REQUEST

Current Zoning: NC (neighborhood center)
Proposed Zoning: MUDD-O PED (mixed use development, optional, Pedestrian Overlay)

Approximately 0.94 acres located at the southeast intersection of Commonwealth Avenue and The Plaza, north of East Independence Boulevard.

The petition proposes to allow for the redevelopment of a parcel utilized as surface parking with multi-family residential and commercial uses. Golden Triangle #7 – Commonwealth, LLC, Levine Properties, Inc. Levine Properties, Inc. Brittany Lins and Collin Brown, Alexander Ricks, PLLC Meeting is required and has been held. Report available online. Number of people attending the Community Meeting: 26

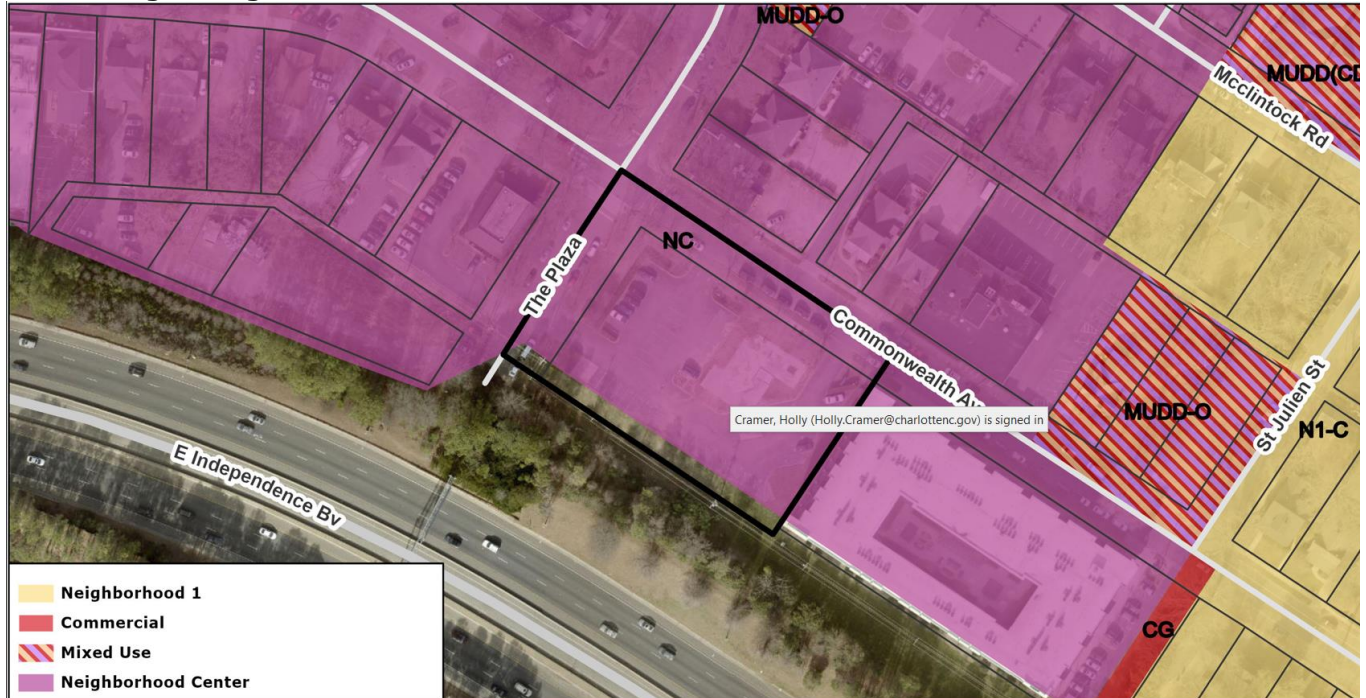
This proposal would allow for an internal drive-through on the site. Such a use opposes the intent of the recommended Place Type and existing overlay as it relates to mobility, and subsequently renders the proposal inconsistent with Community Activity Center. Staff is requesting the removal of the optional provision that allows for a drive-through on the site. If the rezoning is approved, the site's adopted place type would be revised to Commercial. This is an inappropriate place type for the area given its auto-centric nature and range of allowed uses that are incompatible with the neighborhood's current and future, desired development.

- Requests an optional provision to allow for an accessory drive-through service window limited to use as a financial institution. If provided, this will be part of the larger mixed-use building rather than separate.

- Requests an optional provision to exceed the maximum height provisions for the MUDD district.
- Requests a maximum height of **126' 150'**. Commits to provide community benefits consistent with the bonus provisions set forth in UDO section 16.3 for any building height beyond 120'.

3. ~~Reduce the maximum height to provide contextual sensitivity to the surrounding building forms.~~ **Addressed**
4. Revise note 7 under the Design Guidelines to commit to community benefits to achieve building height above 80'. Commit to specific community benefits.

-
- ~~5. Identify building envelopes(s) rather than one development area.~~ **Rescinded**
 6. Remove optional provision allowing for a drive-through.
-
